Subject: AmerenUE, Callaway Plant Unit 2 (NRC Docket No. 52-037)
Response to RAI No. 12 (eRAI 2447), Revision 0, SRP Section 03.11
- Environmental Qualification of Mechanical and Electrical
Equipment

Response to RAI No. 12 (eRAI 2447), Revision 0

Figure 8.3-1—(Emergency Power Supply System Single Line Drawing - Sheet 1 of 3)

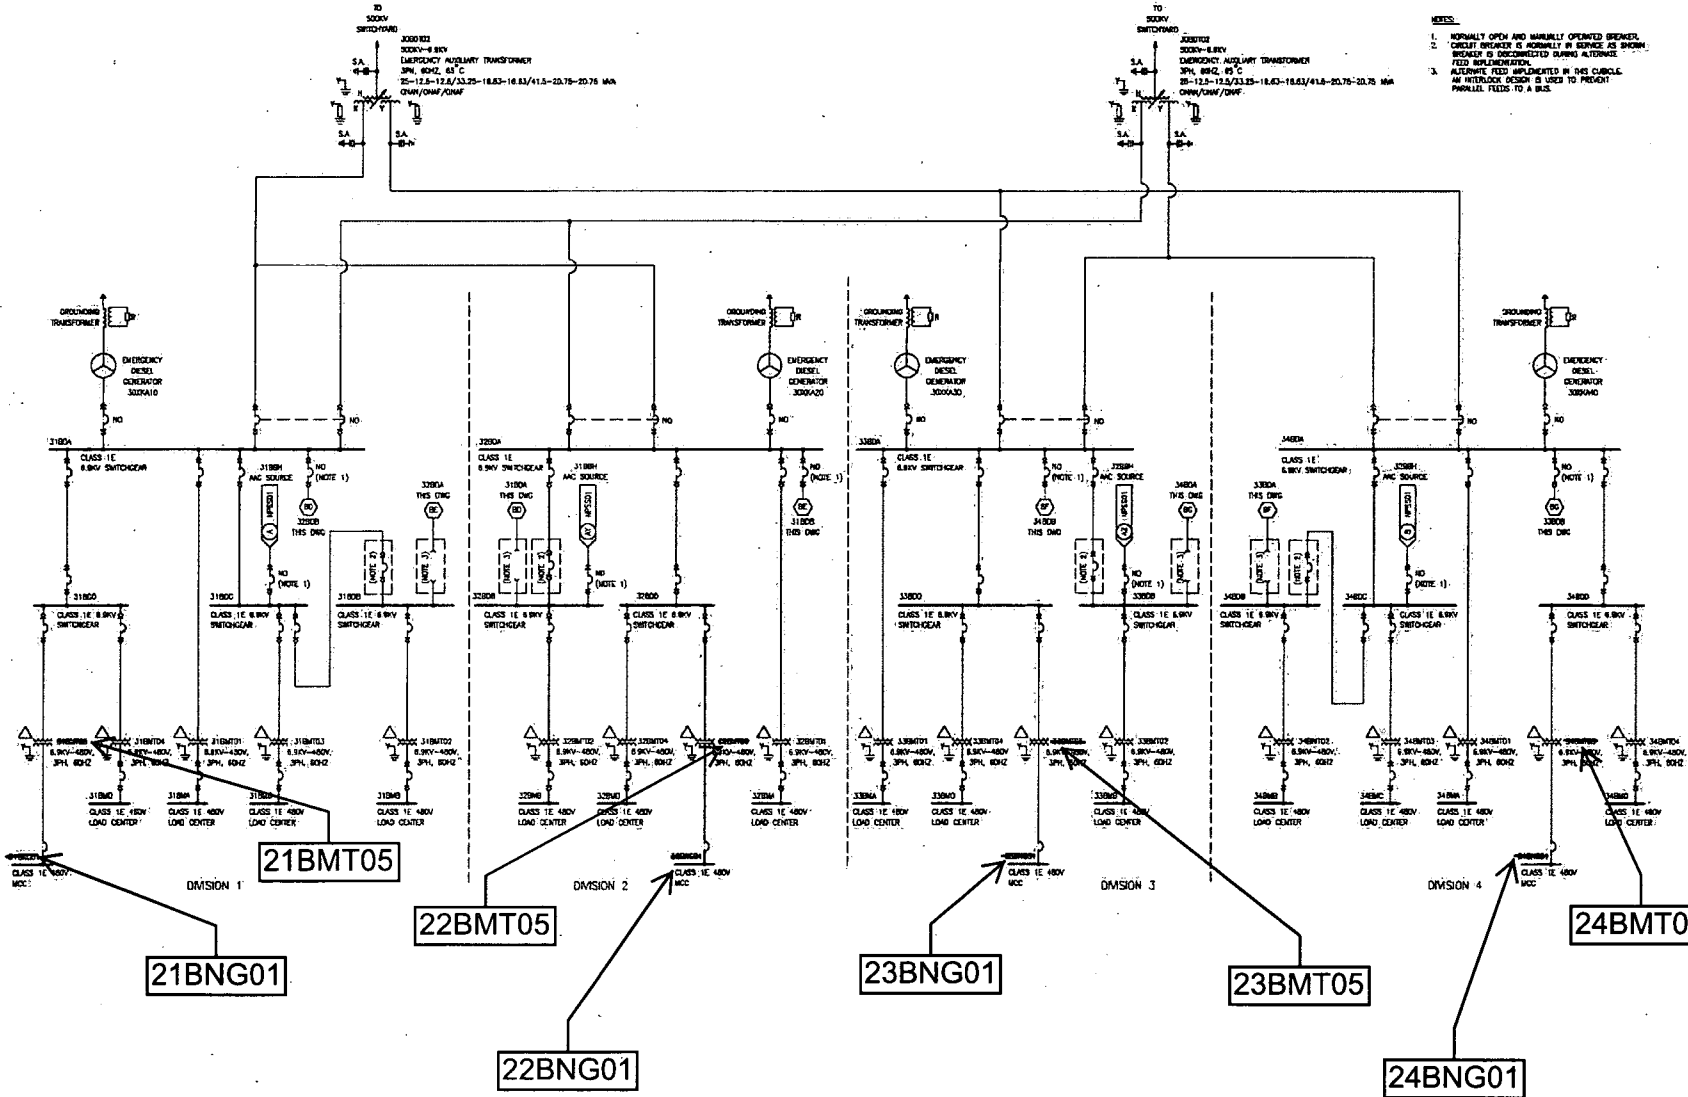
FSAR Table 3.11-1, page 3-210 states: "Verify the Tag Numbers of the ESWEMS Pumphouse Class 1E 6.9 kV-480 V transformers and ESWEMS Class 1E Motor Control Centers." These are inconsistent with the Tag No.s for the same equipment shown in Figure 8.3-1, "EPSS Single Line Diagram." Please reconcile the inconsistency and amend your FSAR accordingly.

The tag numbers for the ESWEMS Pumphouse Class 1E equipment given in FSAR Table 3.11-1 are correct. The tag numbers given for the same equipment shown in Figures 8.3-1 through 8.3-3 "Emergency Power Supply System Single Line Drawing" and Tables 8.3-1 through 8.3-2 are incorrect and will be revised to reflect the numbers provided in Table 3.11-1 as shown in Enclosure 3, Proposed COLA Changes Associated with the Response to Question 03.11-2.

FSAR Figures 8.3-1, through 8.3-3 and Tables 8.3-1 through 8.3-2 will be revised to reflect correct tag numbers for the ESWEMS Pumphouse Class 1E electrical equipment as shown in Enclosure 3 during the next formal revision of the Callaway Plant Unit 2 COLA.
